Town of Hull

BOARD OF SELECTMEN

June 4, 2014

The Town of Hull offers the following comments regarding the Coastal Storm Damage Reduction Project proposed by the Army Corps of Engineers (ACOE) for the Department of Conservation and Recreation (DCR) Nantasket Beach Reservation. Our comments address the benefit to cost ratio (BCR) analysis, the impact on the recreational beach and, community involvement.

Location of Paid Flood Insurance Claims
23 Coastal Storms 1978-2007
(with 3 or more claims)

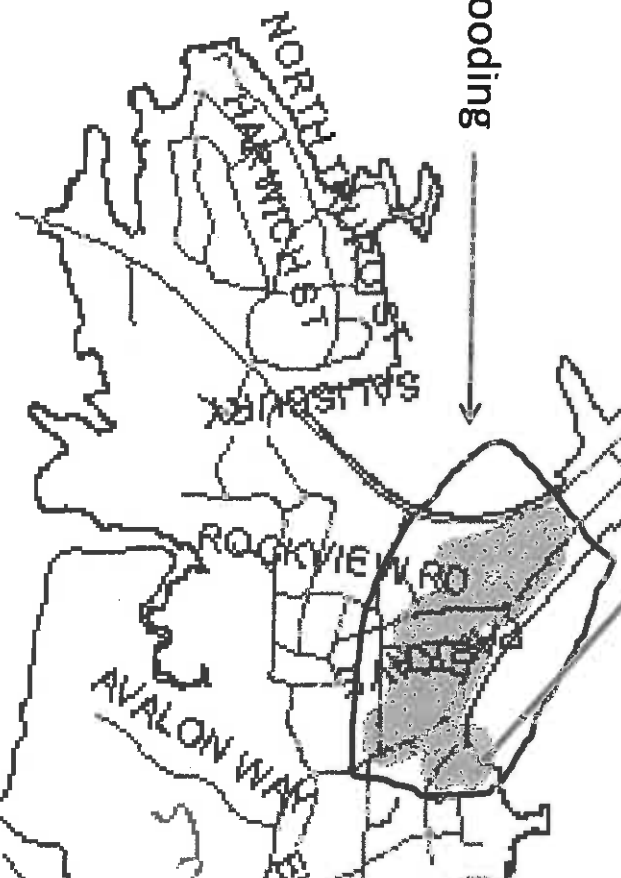
The Town of Hull has invested significant resources in analyzing and addressing flooding and storm damage. As part of this work, the town analyzed FEMA flood insurance claims for the 21 coastal storms that resulted in claims from 1987 to 2007. Attached to this comment letter is a graphic showing the locations impacted by flooding from the DCR Reservation. The graphic clearly identifies the areas vulnerable to overwash flooding from Zones 1 and 3. While the

properties in Zone 3 are also impacted by overwash originating north of the reservation, overwash from the reservation is significant. Both of these areas have been identified by the town as flooding "hotspots" due to the concentration of FEMA repetitive loss properties located there. In addition, the graphic reflects that the properties landward of Zone 2 have been least affected by overwash flooding.
